PLANNING COMMISSION STAFF REPORT

Originator Kris Aaker Assistant Planner	Meeting Date February 25, 2015	Agenda # B-15-04
--	--	----------------------------

DATE: February 18, 2015
TO: Cary Teague – Planning Director
CC: David Fisher – Building Official
Ross Bintner P.E. - Environmental Engineer
FROM: Charles Gerck EIT – Engineering Technician
RE: **4214 Scott Terrace - Special Review CUP**

RE: Request for Variance – Increase first floor elevation

Proposed Site Plan Survey For:

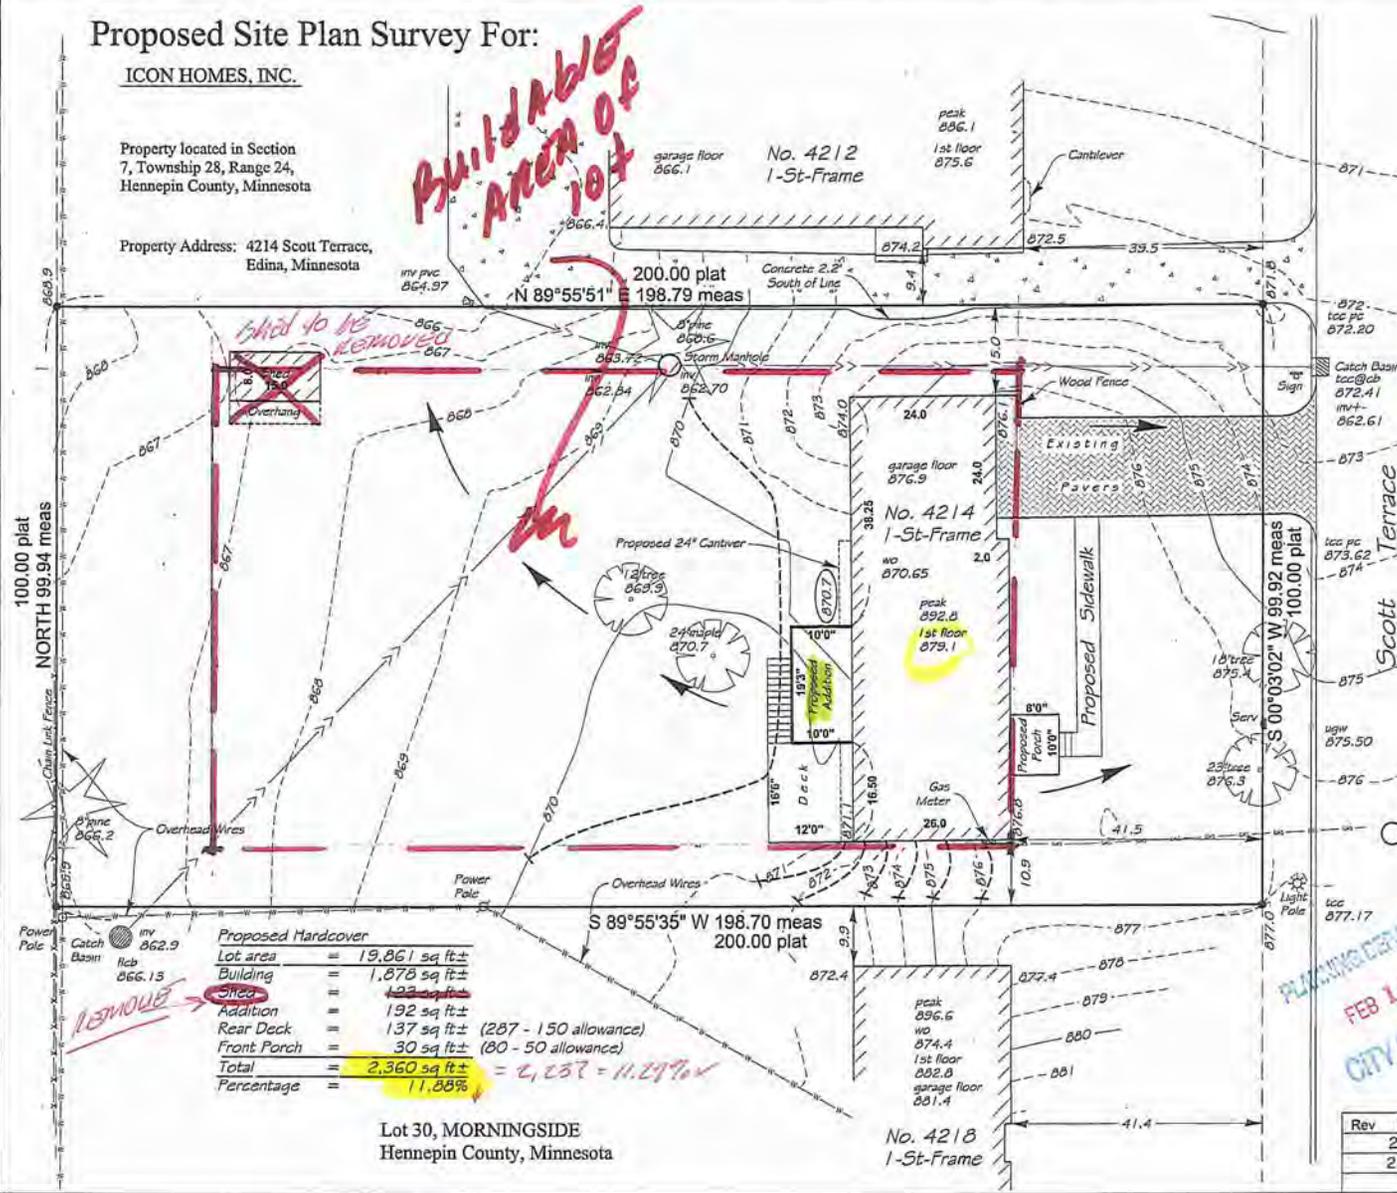
The lot for 4214 Scott Terrace is located in a FEMA flood plain with a recently revised 100-year flood elevation of 869.2'. Per section 3.1.1.1 of the City of Edina Comprehensive Water Resources Management Plan:

In accordance with this policy, your low floor elevation will need to be no lower than 871.2' before we can approve the building permit. Also in accordance with the FEMA flood plain, no fill can be placed at any elevation lower than 869.2'.

Please revise your plans and resubmit hard copies to the building department for review. If you have any questions or concerns, please feel free to contact me at the number below.
